N13.14 (formerly N721)
"Internal Dosimetry Standards for Tritium"

SUBJ: N13.14 (formerly N721)

Topic: Final Approval of Proposed Standard N721
Internal Dosimetry Standards for Tritium

FIGURE 1 LONG TERM TRITIUM EXCRETION DATA (MOGHISSI 1978)

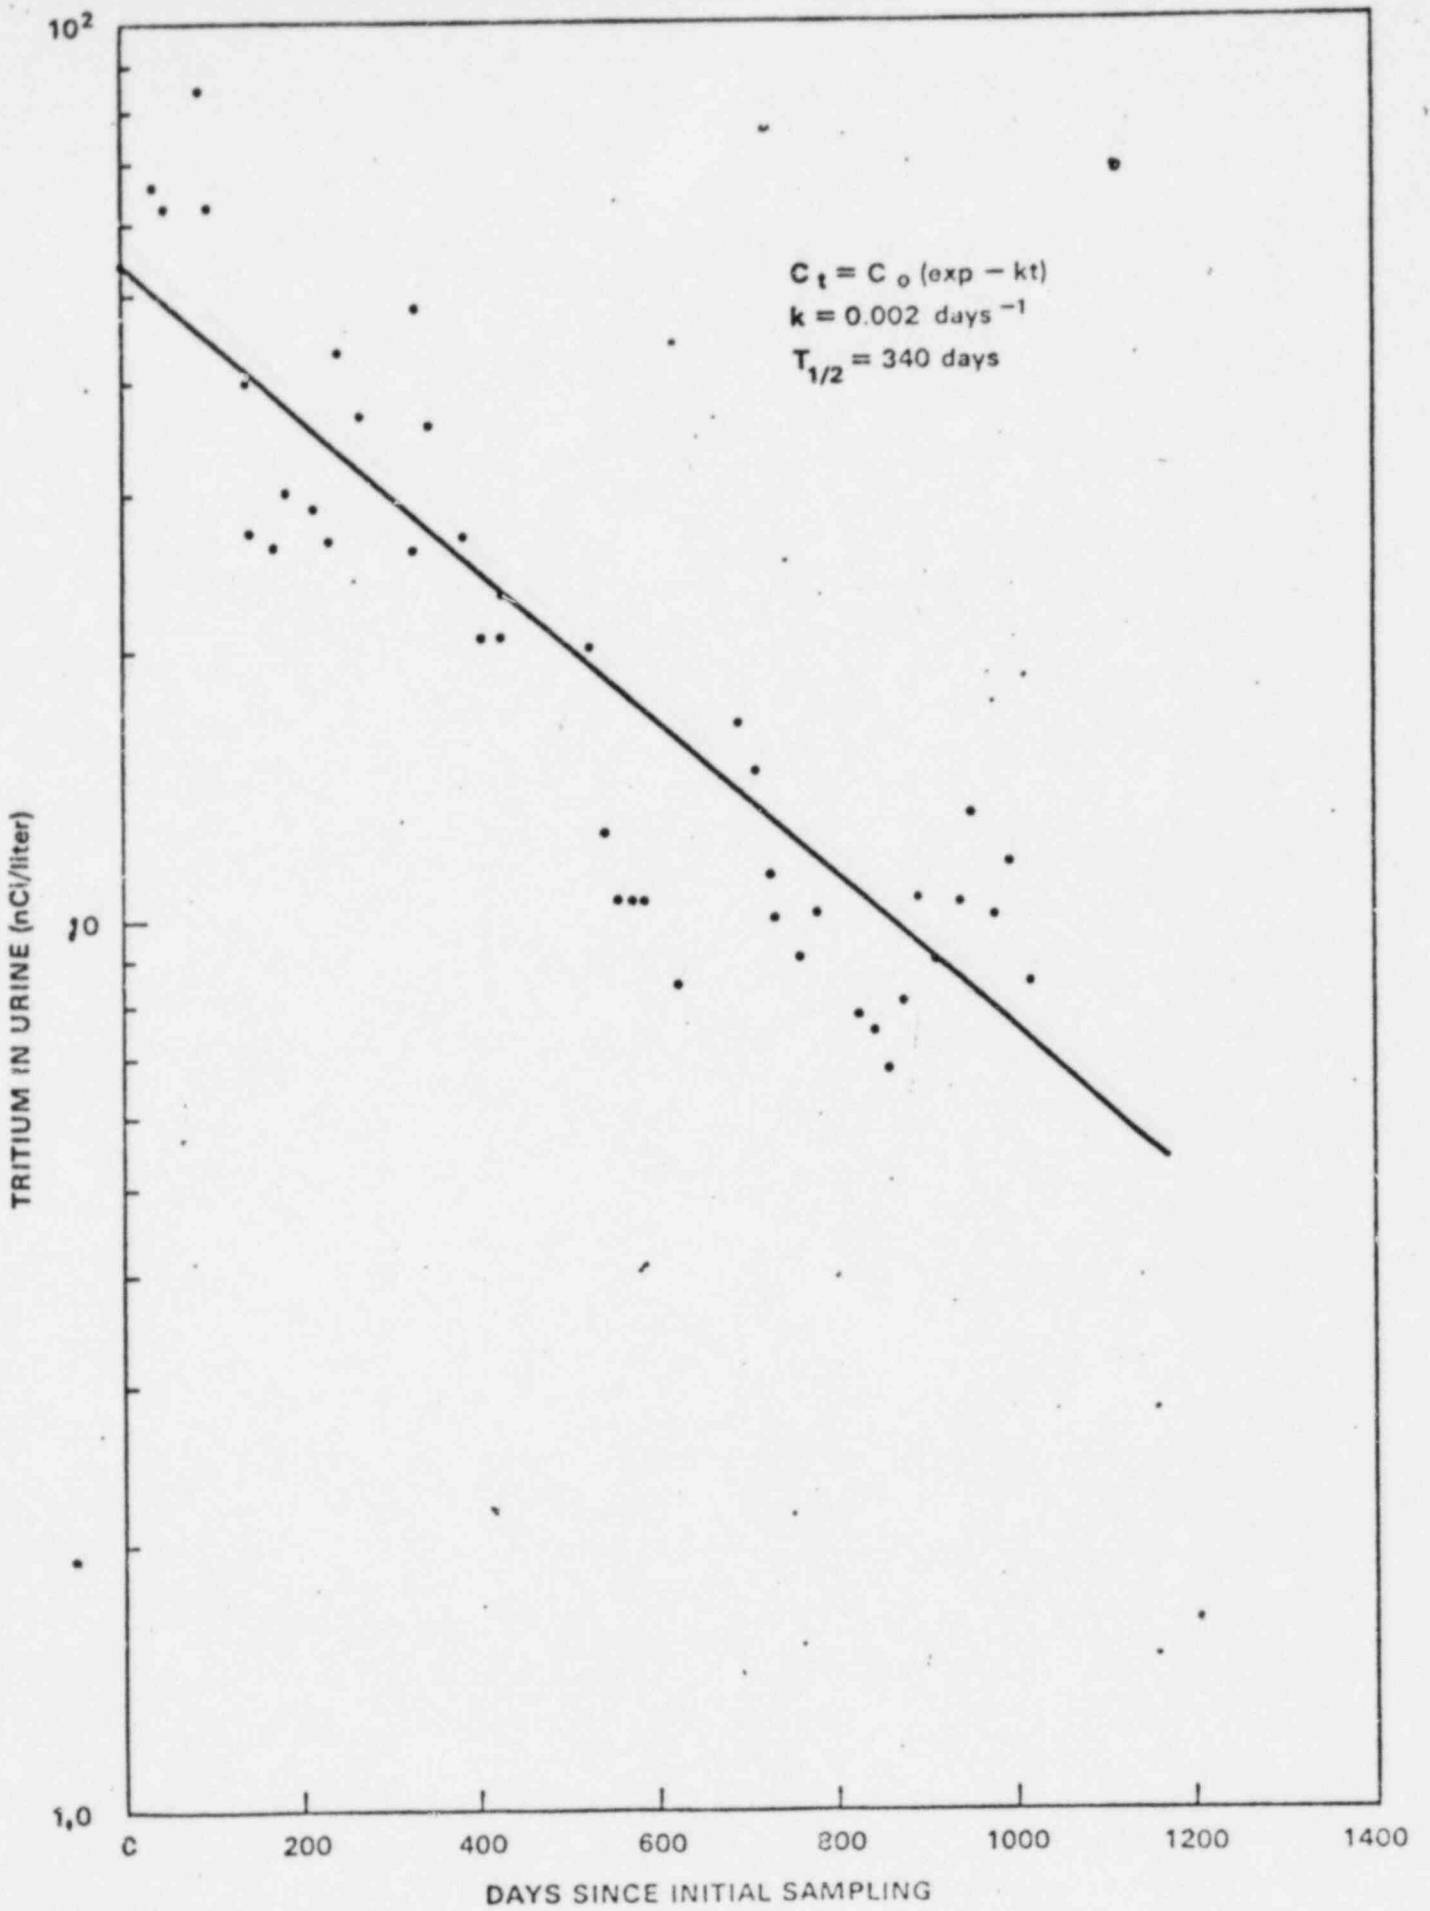
10.1.1 For Purposes of Preparatory Evaluation

This section states that the previous radiation history of new employees will be reviewed and that this will include the results of new bioassay data. The kinetics given in Section 9.0, however, are not sufficient to evaluate dose commitments for some former tritium workers returning to the industry.

Figure 1 is a long-term tritium excretion curve from a former tritium worker. Sampling was initiated about six months following termination of employment. A specific activity model from the results of the first sample (0.055 uCi/l) would indicate a body burden of:

$$0.055 \text{ uCi/liter} \times 43 \text{ liters} = 2.4 \text{ uCi}$$

The actual body burden at $t = 0$ is, however,:

$$Q_3 = \frac{0.055 \text{ uCi/l} \times 3 \text{ l/day}}{0.002 \text{ day}^{-1}}$$

$$Q_3 = 83 \text{ uCi}$$

It was calculated in the previous section that this long-term component (Q_3) was associated with about 6.4 kg of tissue so that the time integrated unit weight concentration would be:

$$\frac{83 \text{ uCi} \text{ day}}{6.4 \text{ kg} \cdot 0.002} = 6500 \frac{\text{uCi} \cdot \text{day}}{\text{kg}}$$

This is significantly higher than if it were assumed that 2.4 uCi were distributed equally throughout 43 kg of water with a 10 day half-time:

$$\frac{2.4 \text{ uCi} \text{ day}}{43 \text{ kg} \cdot 0.0693} = 0.8 \frac{\text{uCi} \cdot \text{day}}{\text{kg}}$$

It is thus possible to underestimate a unit tissue dose by a factor of 8000 in this instance.
